# MR #2023006 – LIFE SCIENCE CENTER LOOP TRAIL MANDATORY REFERRAL AND WATER QUALITY PLAN

NO. MR2023006

Medical Center Drive/Omega Drive between the City of Gaithersburg and Great Seneca Highway

Montgomery County Department of Transportation

Figure 12: Medical Center Drive at Broschart Road

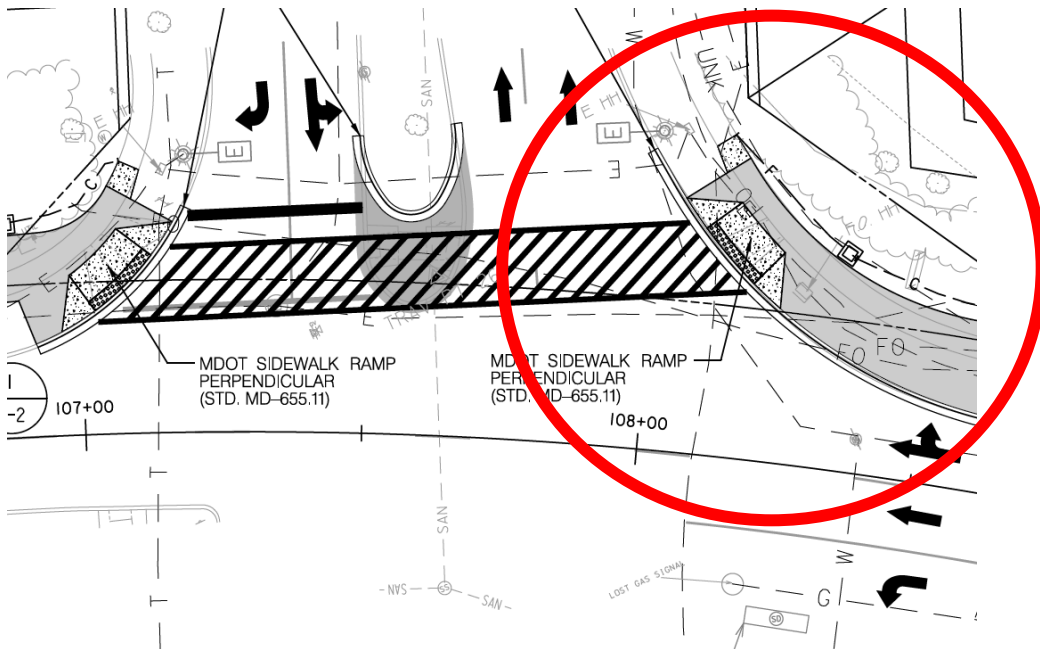
**Recommendation: Tighten curb radii at all intersections and driveways in line with the Complete Streets Design Guide (CSDG) default radii (15 feet). Where wider turning radii may be helpful for larger vehicles or emergency operations, consider the use of mountable curbs or relocating the receiving leg stop bar to allow for encroachment.**

Providing tighter turning radii is essential to reducing the turning speed of motor vehicles, improving visibility between motorists, pedestrians, and bicyclists, and reducing the likelihood and severity of collisions between roadway users. Figure 11 illustrates how tighter turning radii improve visibility by allowing motorists to cross bikeways, sidewalks, and sidepaths at a perpendicular angle so potential conflicts can be seen through the front windshield, not over a shoulder.

Additionally, the smaller the curb radius, the less roadway pedestrians have to cross, reducing their exposure to conflict. Figure 12 illustrates that the turning radius issue at the circled corner of the intersection with Broschart Road is excessive and should be tightened.

Figure 14: LSC Loop Trail Intersection with Mis-aligned Curb Ramps

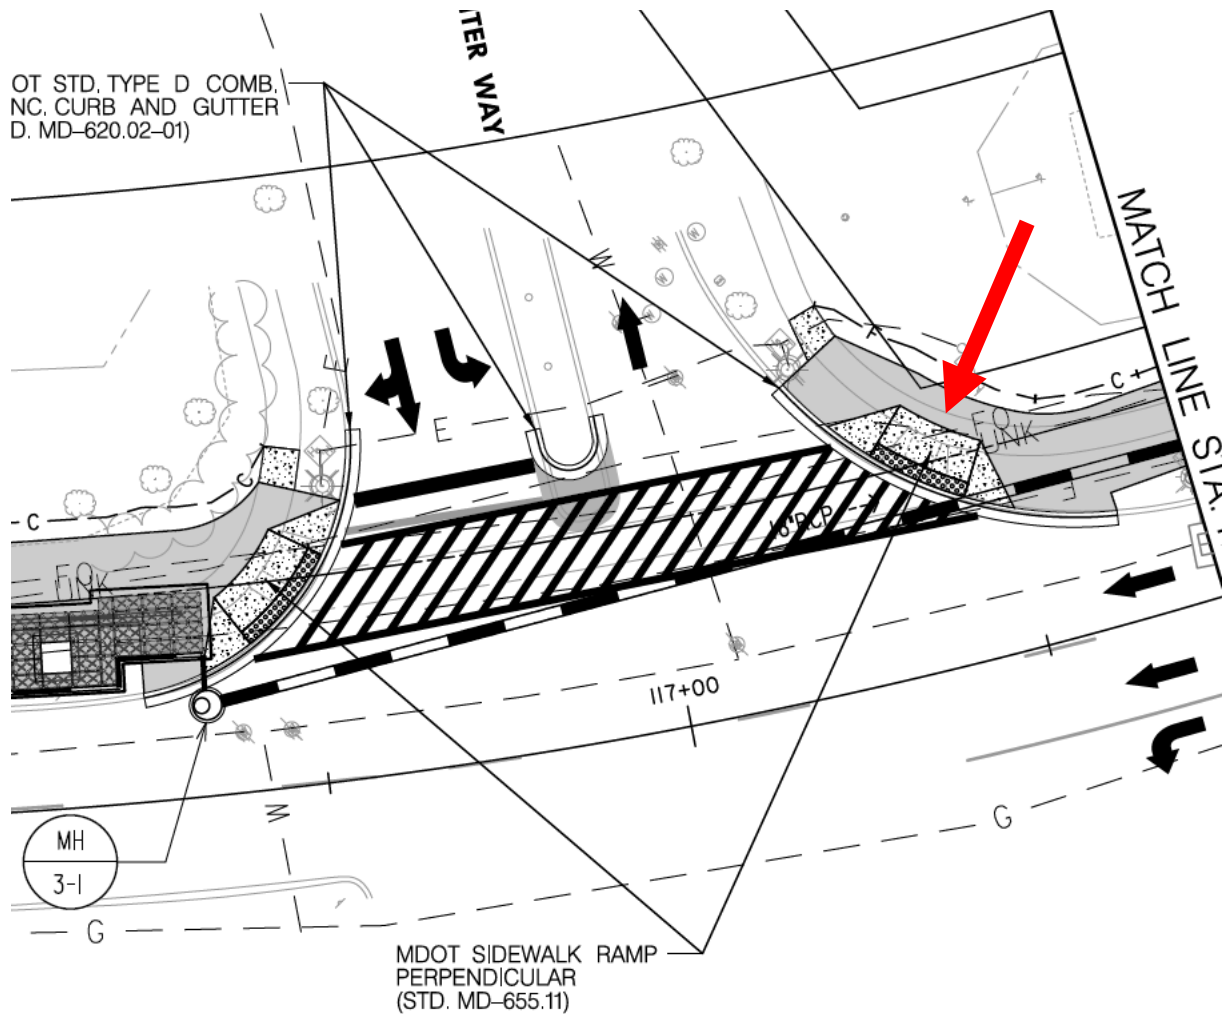
**Recommendation: Provide directional curb ramps that are aligned with high-visibility marked crosswalks at all street and driveway crossings, including at Stations:**

Directional curb ramps aligned with marked crosswalks are a best practice because they guide pedestrians along the shortest path across the street or driveway, reducing pedestrian exposure to traffic. When curb ramps are oriented toward the middle of an intersection (Figure 14), people with low or no vision and those using wheelchairs or other mobility devices can be directed to cross the street outside of the intended path of travel.

Figure 15: Potential Pedestrian Refuge Location

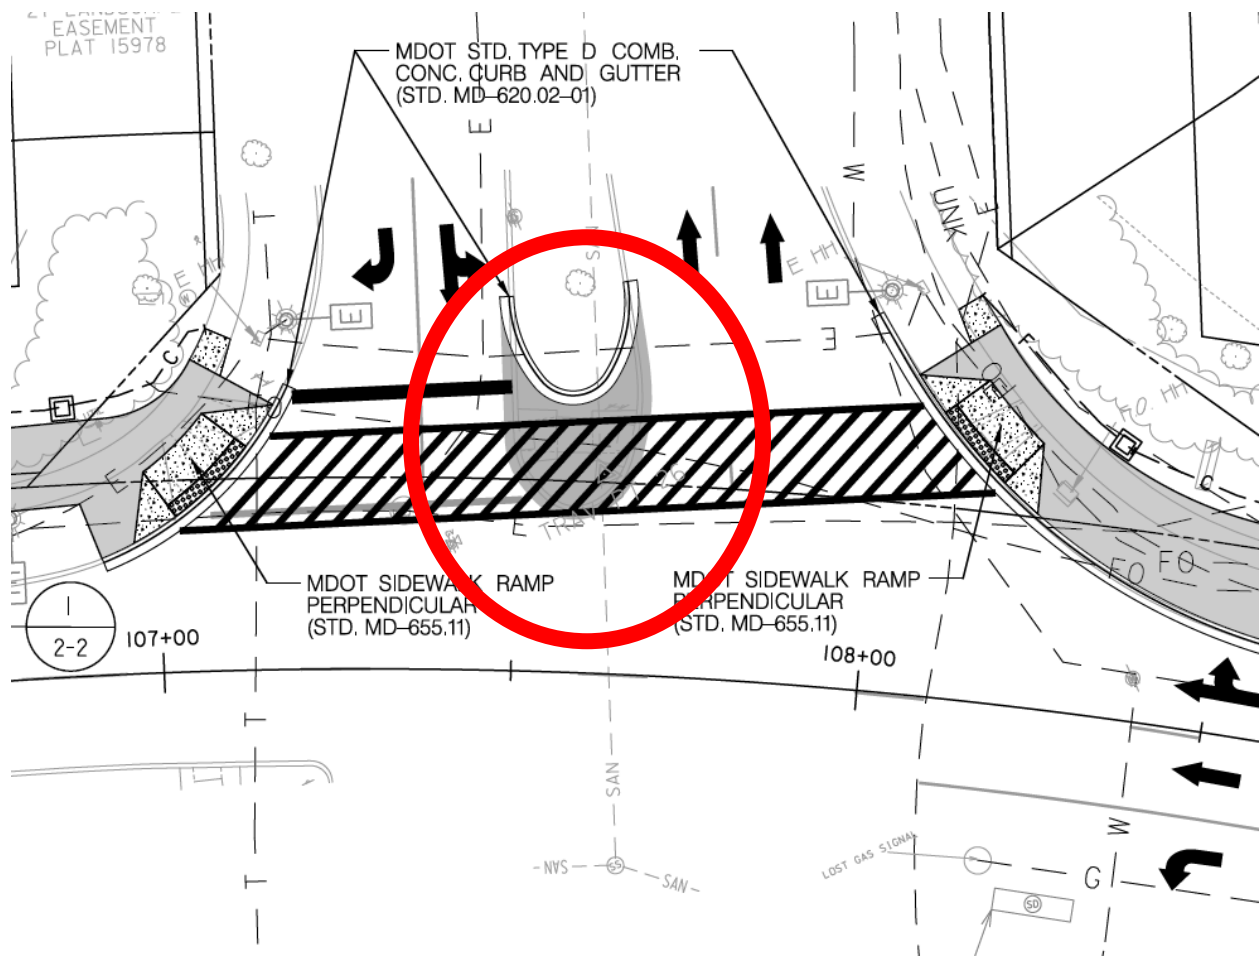
**Recommendation: Construct new 12-foot-wide pedestrian median refuges at the following Stations:**

- a. 107+50\* (Broschart Road)
- b. 200+00 (Key West Avenue)
- c. 204+50 (Driveway north of Key West Avenue)

\*For the Station 107+50 location, it appears that the existing median refuge would be removed as part of this project.

- 1) It reduces pedestrian exposure to traffic by minimizing the time pedestrians are actually in the roadway.
- 2) It provides a midway resting point for slower pedestrians.
- 3) It allows pedestrians to cross only one direction of travel at a time, particularly at uncontrolled or stop-controlled locations like at Broschart Road (107+50) and the Decoverly Development driveway (204+50), as shown in Figure 15.

Figure 17: Great Seneca Highway at Medical Center Drive from Elms at PSTA Certified Site Plan

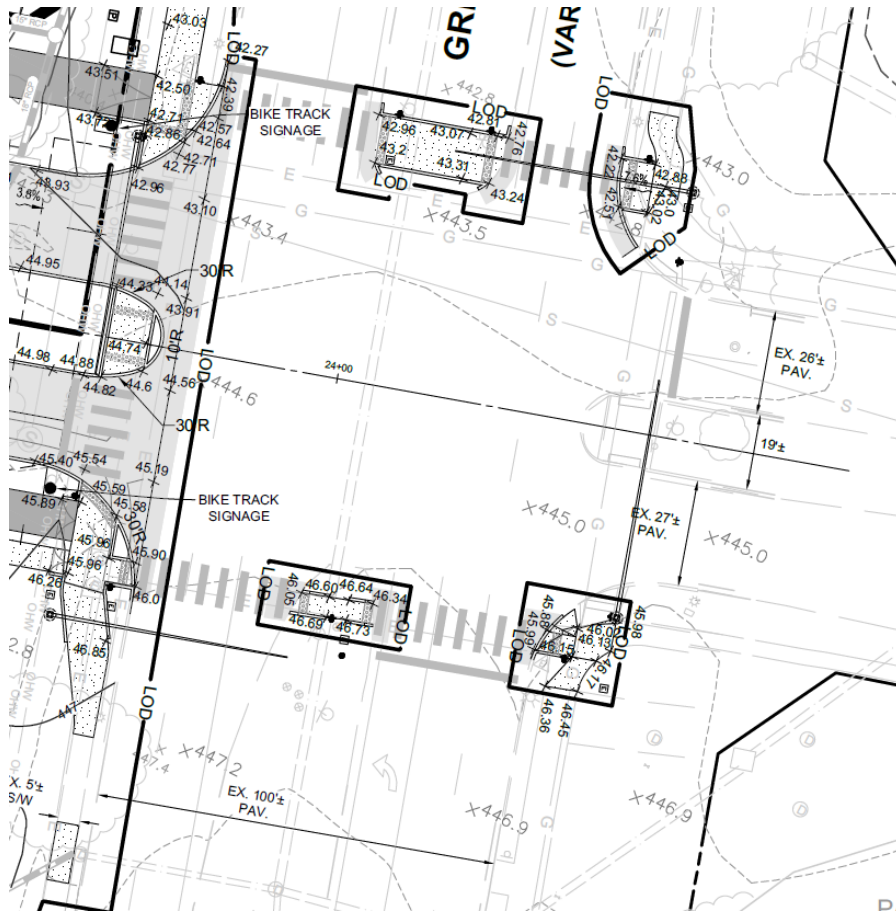
**Recommendation: Ensure the project’s Great Seneca Highway terminus appropriately transitions to the segment of the LSC Loop Trail currently under construction as part of the Elms at PSTA project.**

The Elms at PSTA project is currently under construction, and as previously discussed, the LSC Loop Trail continues through that site west of Great Seneca Highway. The proposed project should ensure a smooth transition across Great Seneca Highway between the two segments. Based on a review of the Elms at PSTA Certified Site Plan (Attachment E)(Figure 17), there are currently discrepancies with ramp design and location that should be resolved as this plan moves toward 100% design.

Figure 18: Six-Foot Buffer with Transformers Identified

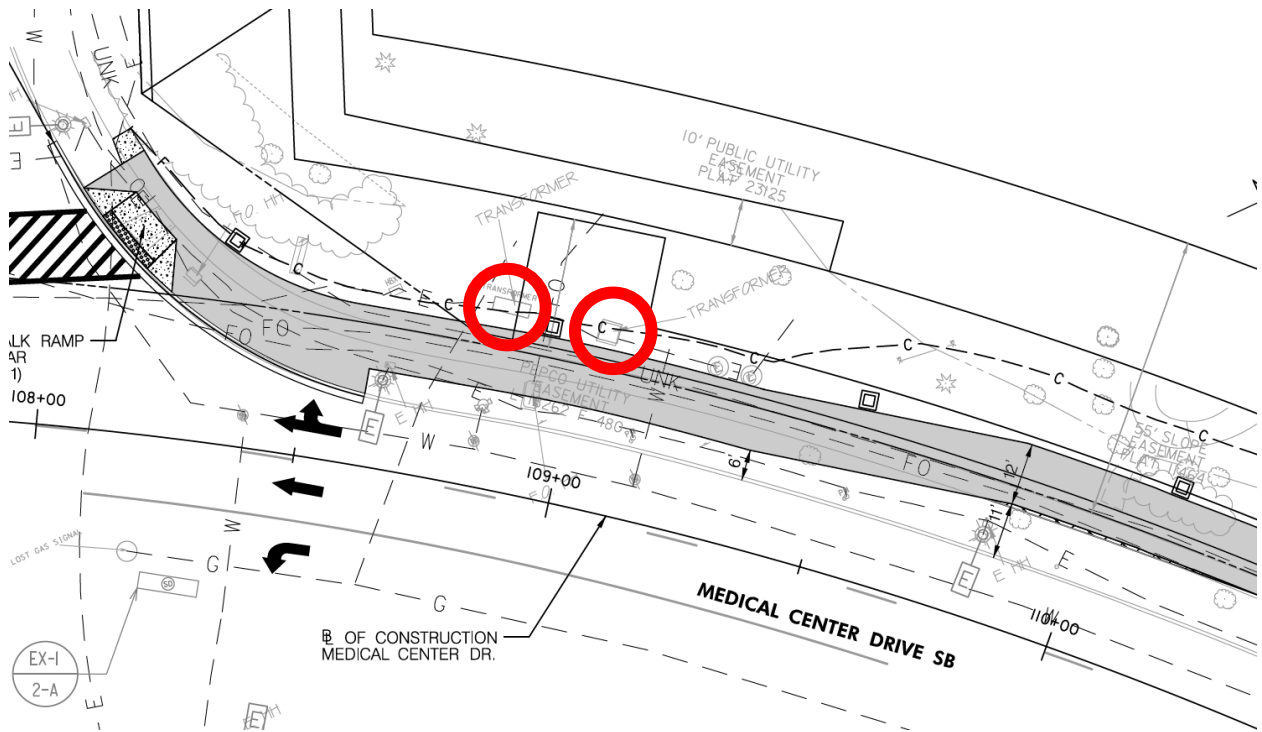
**Recommendation: Relocate transformers at Station 109+00 to continue the 11-foot-wide street buffer.**

From Station 108+00 to Station 110+00, the buffer between the sidepath and the roadway narrows to 6 feet from 11 feet. The project team should consider working to relocate the transformers (highlighted in red in Figure 18) in that section to maintain a consistent 11-foot buffer. This change would also likely allow the sidepath to intersect with Broschart Avenue in a way that improves visibility for all road users by setting the path further away from Medical Center Drive traffic.

Figure 19: Misaligned Driveway Crossing

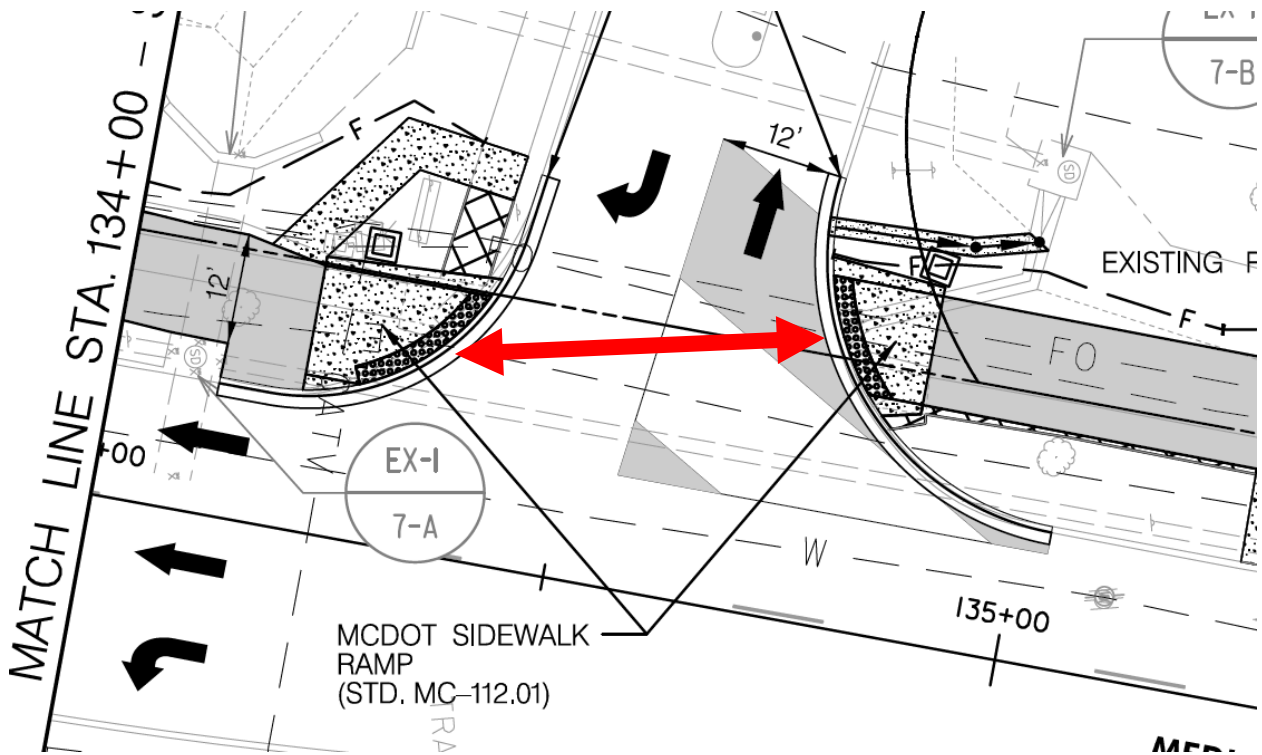
**Recommendation: Widen street buffer at Station 134+00 to eleven feet to better align the adjacent driveway crossing.**

The project team should consider widening the street buffer to 11' to allow the path to travel directly across the commercial driveway, though this may be challenging given that there are stormwater facilities and utilities in this location. The current design (Figure 19) includes a jog across the driveway and an unintuitive and circuitous sidewalk connection.

Figure 20: Eastern Project Terminus

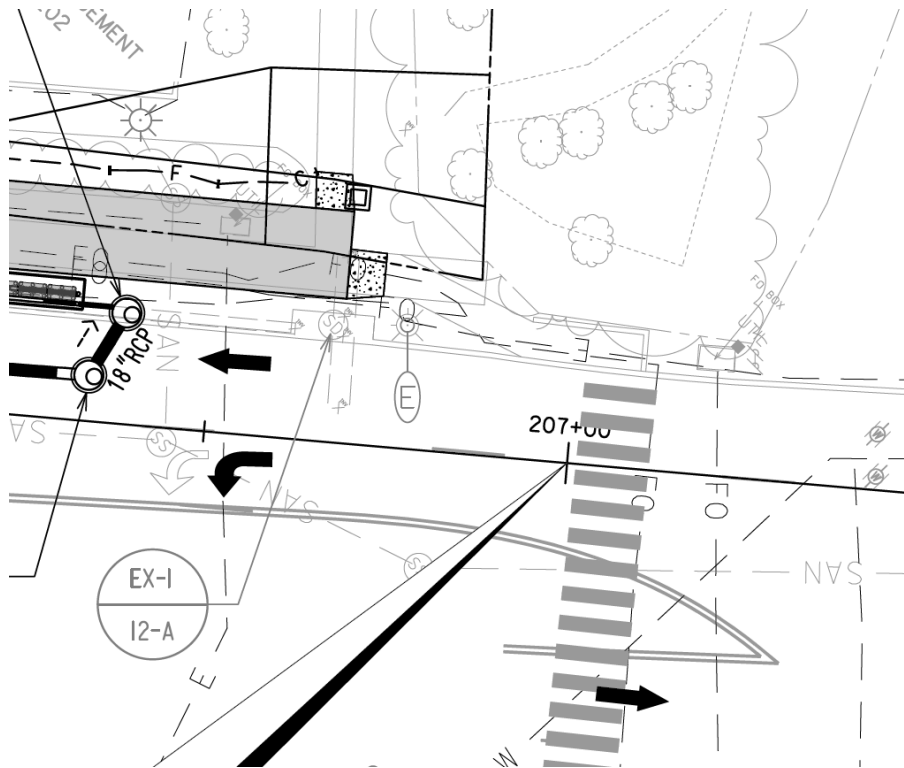
**Recommendation: Consider extending the sidepath from 206+75 to 207+00.**

As shown in Figure 20, the sidepath stops about 35 feet south of a marked crosswalk at Research Boulevard and transitions to an existing sidewalk. The sidepath should be extended to the marked crosswalk so the narrow sidewalk doesn't become a potentially dangerous pinch point for pedestrians and bicyclists using the LSC Loop Trail.
